**Formal Comments on the  
Draft Site-Wide Environmental Impact Statement for  
Continued Operation of the Los Alamos National Laboratory**

April 10, 2025

Mr. Stephen Hoffman  
LANL SWEIS Document Manager  
National Nuclear Security Administration

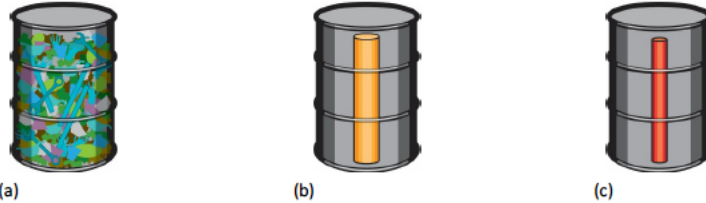
The dilute and dispose plan would produce approximately 160,666 CCOs (based on a total of 48.2 MT of surplus plutonium and 300 FGE per CCC)—more than the number of 55-gallon drums currently emplaced in WIPP. The LWA volume for the DSP-TRU waste, using the numbers above, would be 2,057 m<sup>3</sup> while the TMW volume would be 33,740 m<sup>3</sup>—a factor of 16 larger.

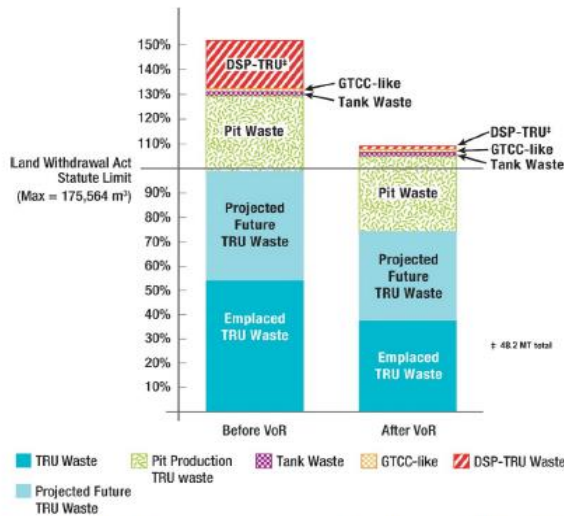
The committee was asked to review additional TRU waste streams and to assess DSP-TRU waste’s potential impact on them as well as the impact on LWA capacity limits. To reassess these impacts against the new volume of record (VoR) calculations, the committee updated the volumes of specific waste streams noted in its Interim Report: Greater-Than-Class-C-like wastes, tank wastes, and TRU waste generated by pit production. Recent DOE-reported volumes for emplaced and future TRU wastes were used (DOE-CBFO, 2018a, 2019a; see Table 3-2). The results shown in Figure S-5 highlight two main issues:

- Under the VoR recalculation, the LWA volume of the DSP-TRU waste generated by processing 48.2 MT of surplus plutonium is reduced from 33,740 m<sup>3</sup> to 2,056 m<sup>3</sup>, which is approximately 1 percent of the LWA capacity, yet the physical volume is substantial (approximately the physical space of two panels); and
- When additional TRU wastes volumes are taken into account, the LWA capacity will still be challenged—primarily due to initial estimates with potentially large uncertainties of TRU waste from pit production.

To conclude, the LANL SWEIS must fully explain and justify how the NNSA can guarantee that the Waste Isolation Pilot Plant will be available for disposal of its plutonium pit production transuranic wastes.
